CONSERVATION DEPARTMENT DETAILED AGENDA

Date: August 25, 2022

1 South
Paradise Lane

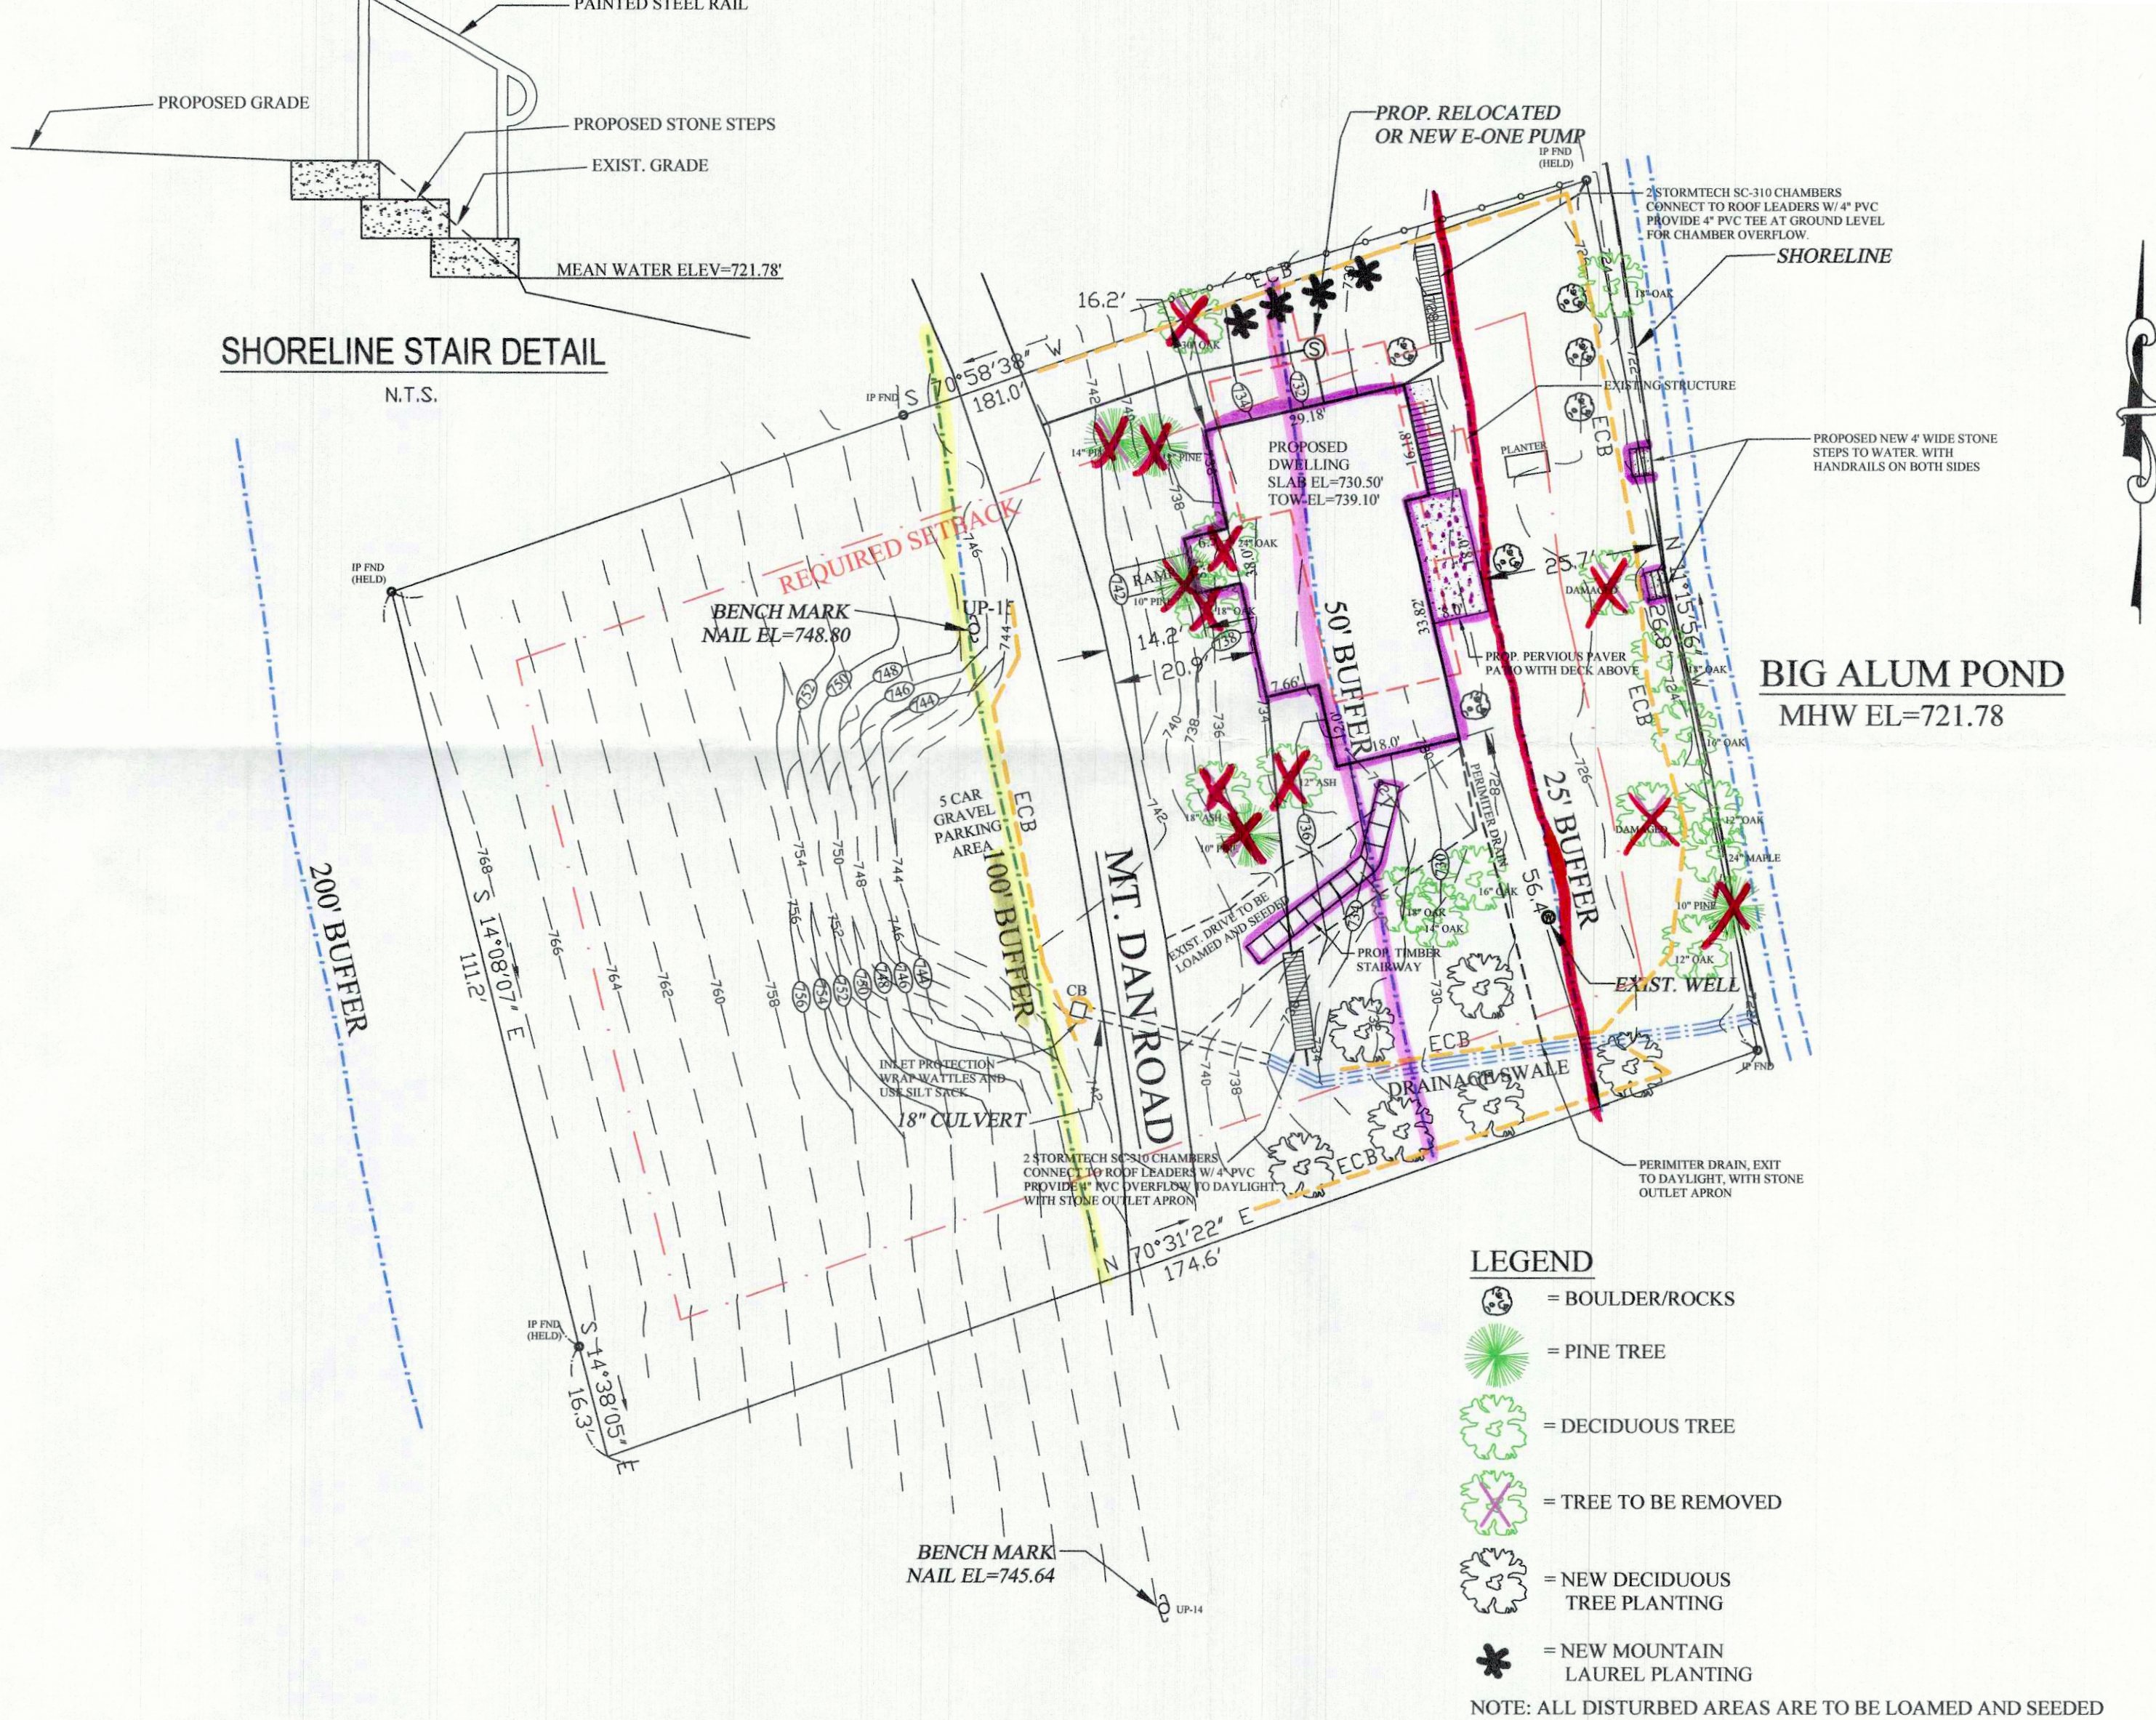
- Existing walls and steps are rotten. Replacement will be in kind. Some landscaping plantings will need to be removed. All work is within developed and maintained areas. Mini excavator to be used to remove old timbers. Old timbers are to be directly loaded into a dumpster and removed. Work proposed to be completed within 3-5 days.

- No work proposed near the lake. The lake is on the other side of the structures. An existing driveway is between the work and the vegetated stream. Work is within BVW to stream. ECs proposed along lower driveway. Recommend just straw wattles during work.

- Site is well vegetated.
 - Building comments-Stairs will require a building permit and need to meet code.
- Staff Recommendation: Close the hearing and issue a DOA:

- Negative #3 with conditions:
 - Standard pre-work and sign off conditions.
 - Straw wattle install btwn work and BVW.
 - Positive #2b: no resource area approval

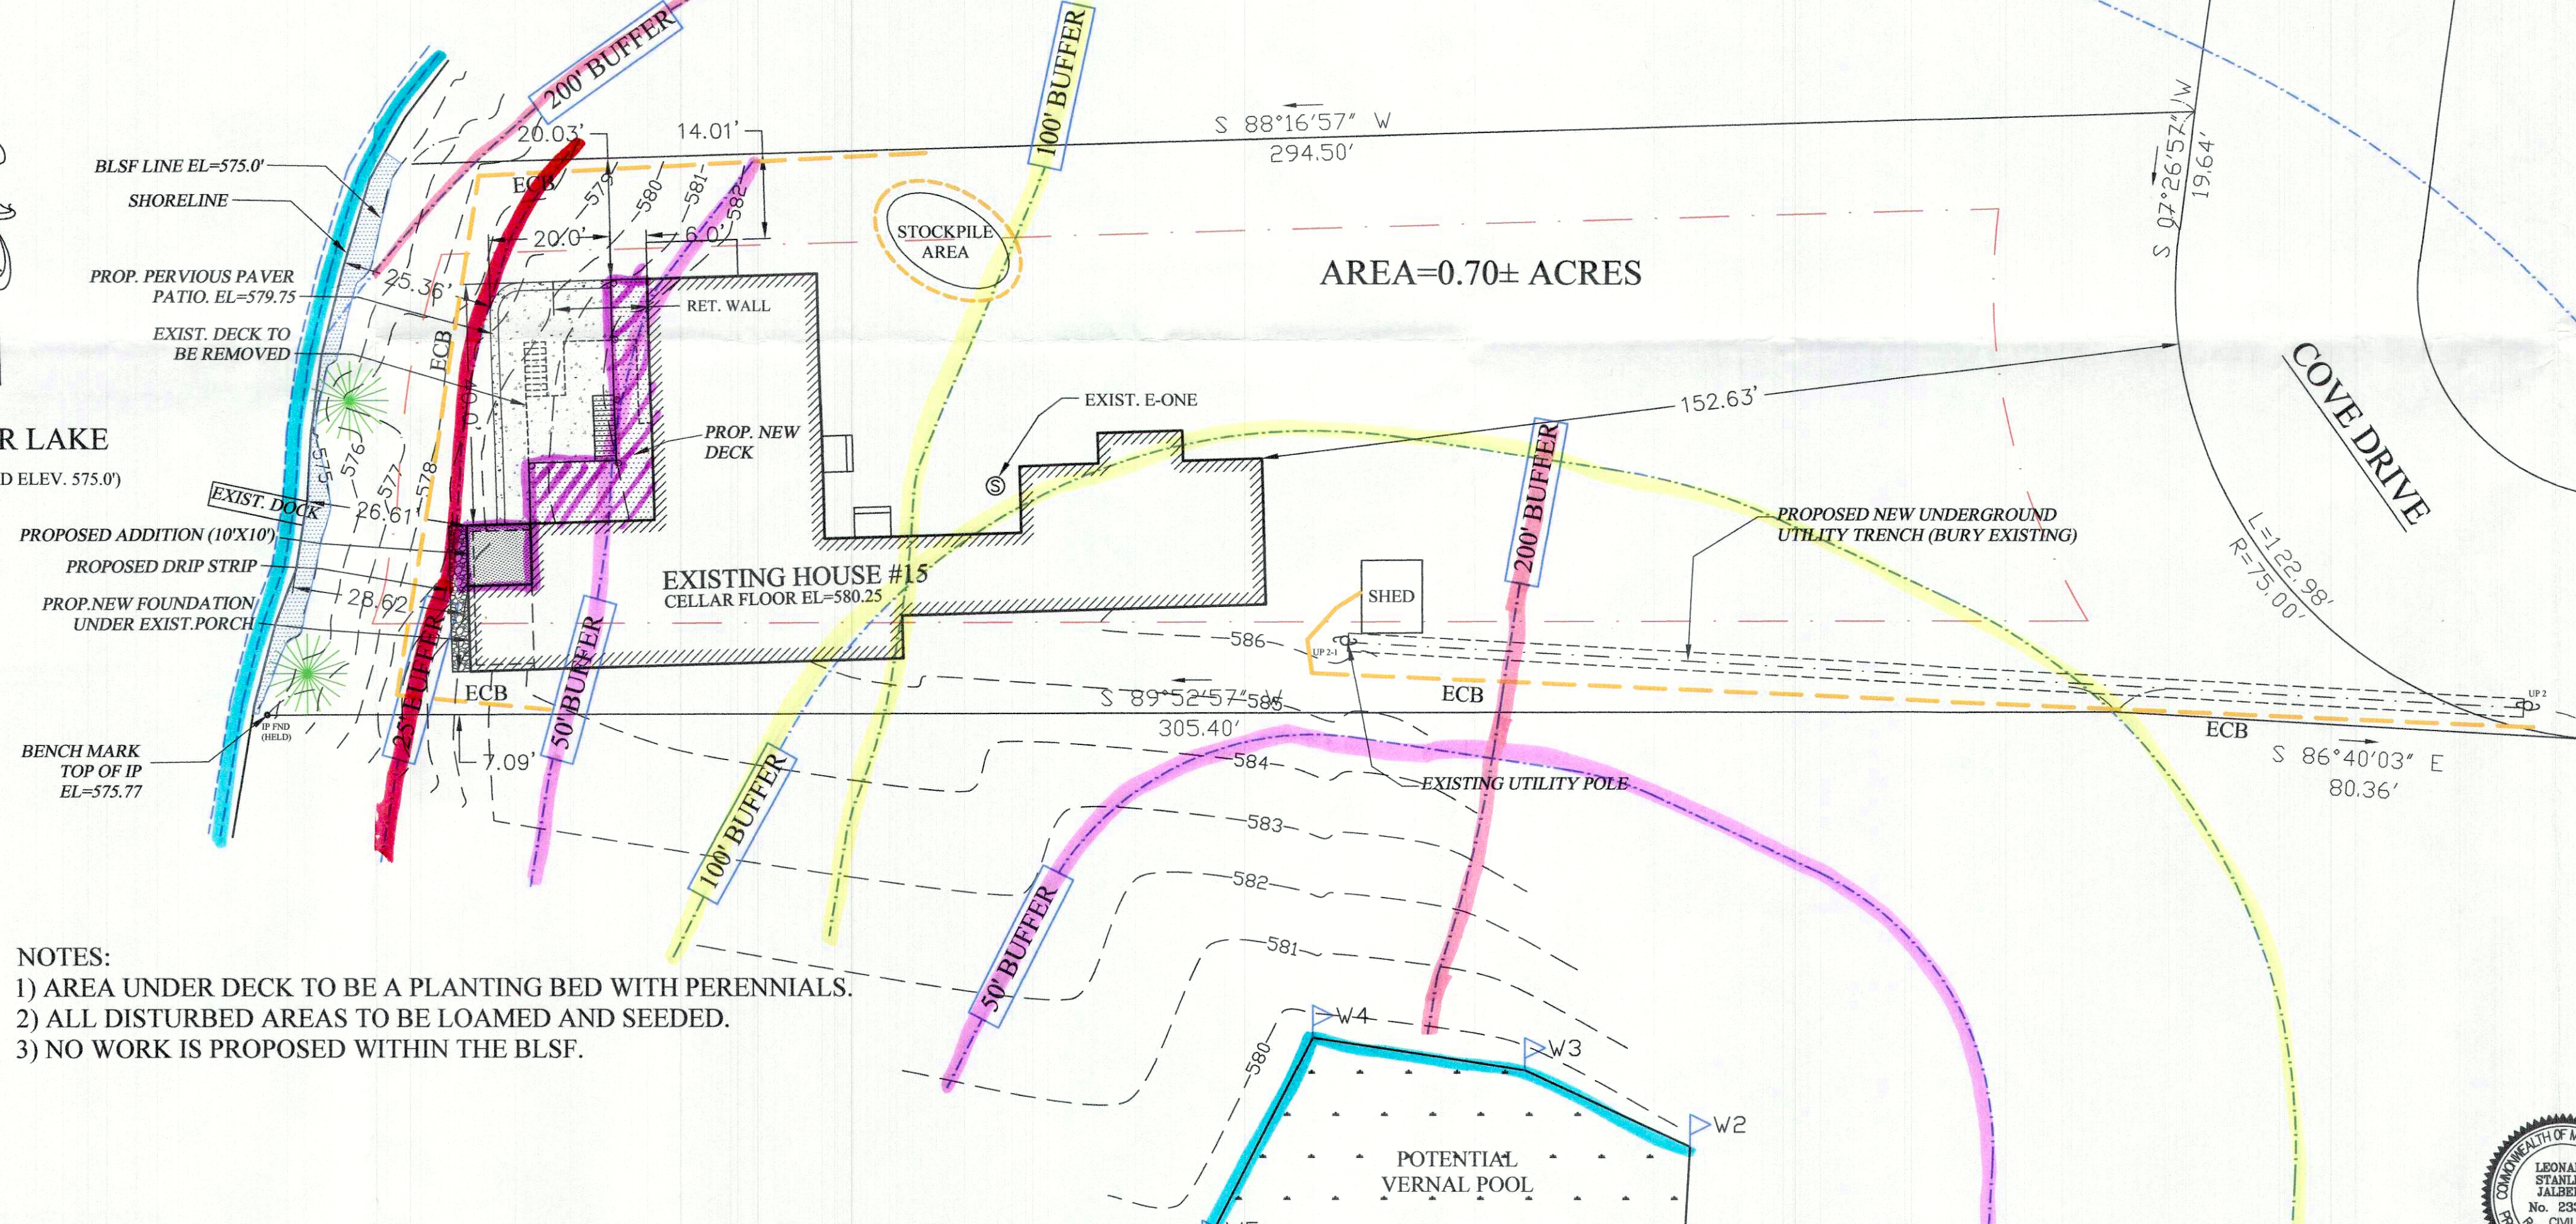
-The proposed work appears to be within the 100-year floodplain (Bordering Land Subject to Flooding). The plans should be revised to show the location of BLSF. If any work is proposed within area, the applicant should demonstrate that the project meets the performance standards for BLSF (310 CMR 10.57(4)), and impacts should be quantified in Section B of the NOI.

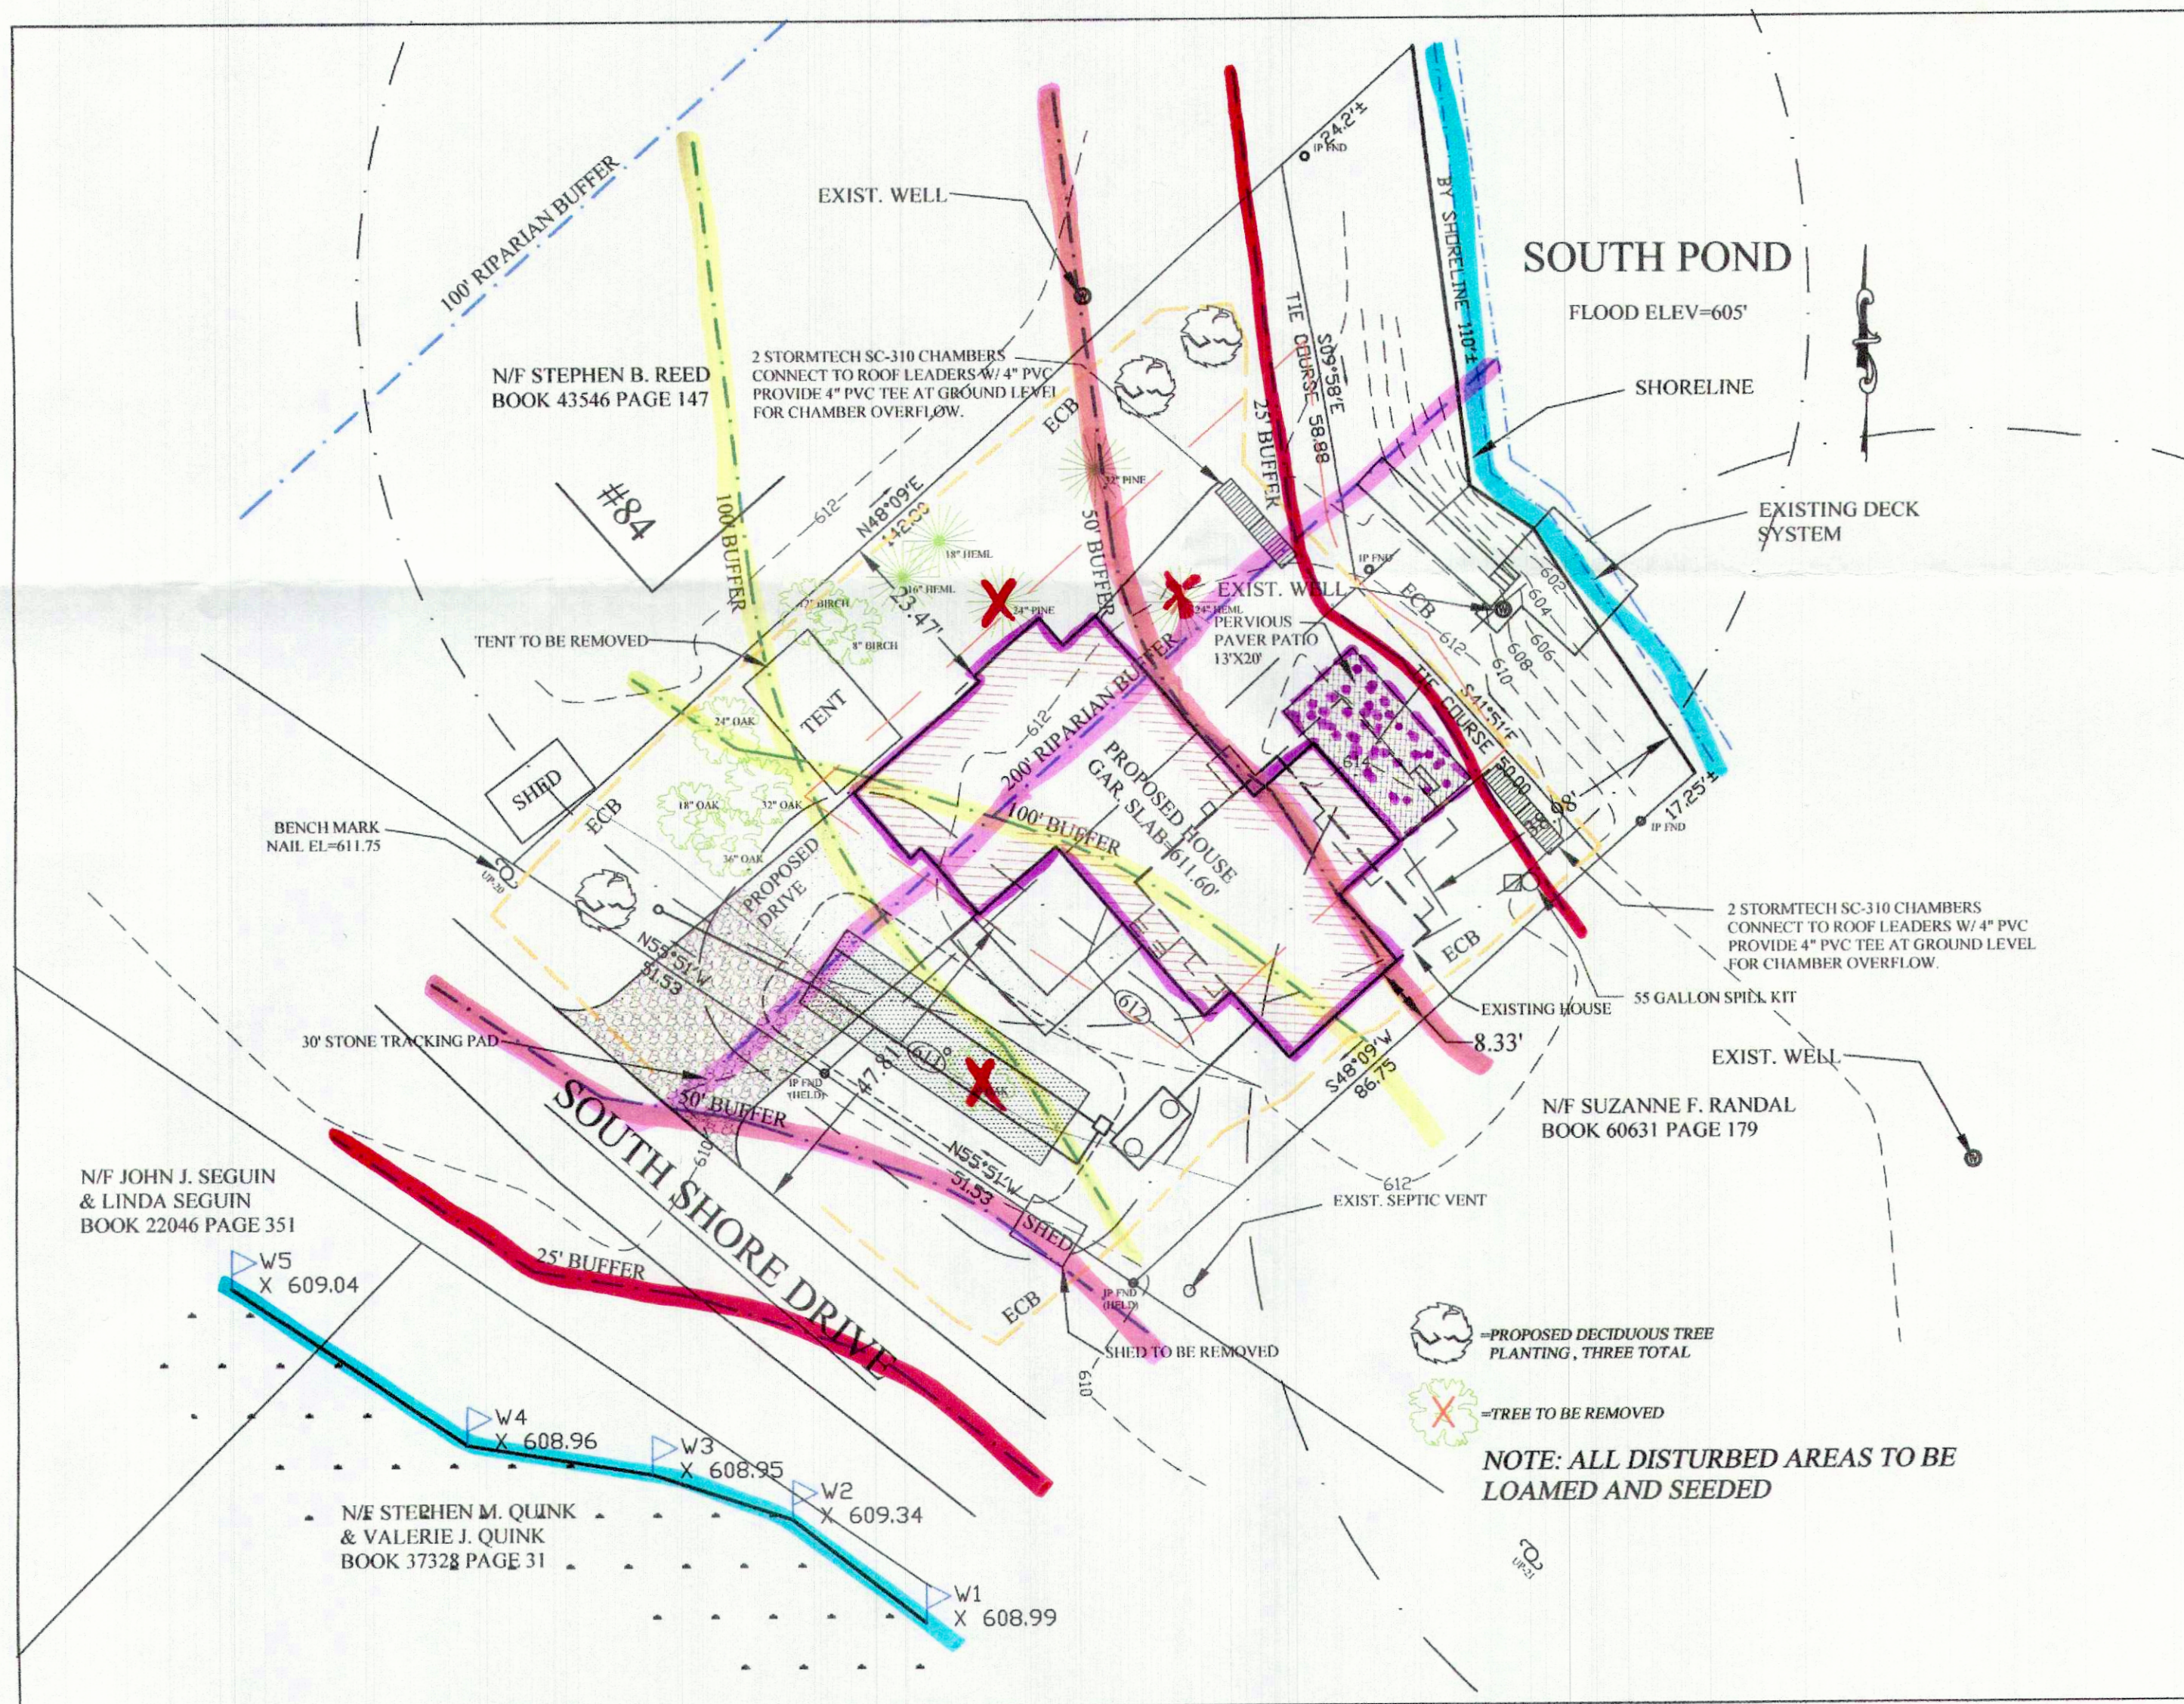
- Revised plan received. Includes BLSF designation. No work shown within BLSF.
 - Site visit conducted.
 - Underground utilities proposed within 50-100’ from PVP and rest of work is within 150-200’ of PVP, however, work is minor and will include digging a small trench. No vegetation (shrubs/trees) proposed to be removed. Staff have no concerns with this.

- New sunroom under existing sunroom appears to be expanded and would be a new structure within 50’ of the lake.
 - New structure is within 50’ no build setback. Alternative analysis must be shown that all alternatives explored before board can consider. A waiver must be requested and mitigation provided. It may be advisable to stay in same footprint of sunroom and not expand here. Appears there are alternative options to the extended sunroom.

- Area under sunroom will require excavation most of material appears to be past fill. Significant tree roots of large pine noted adjacent to this area. Areas beyond existing footprint should not be excavated.

- Potential mitigation options could include improvements along the shoreline to create a vegetated filter strip between the lawn and lake. Herbaceous perennials and shrubs could be planted. Some minor erosion noted along the side yard from downspouts and driveway. It would be a good improvement to install BMPs (i.e. drip strip, underground chambers, etc.) to manage stormwater here.
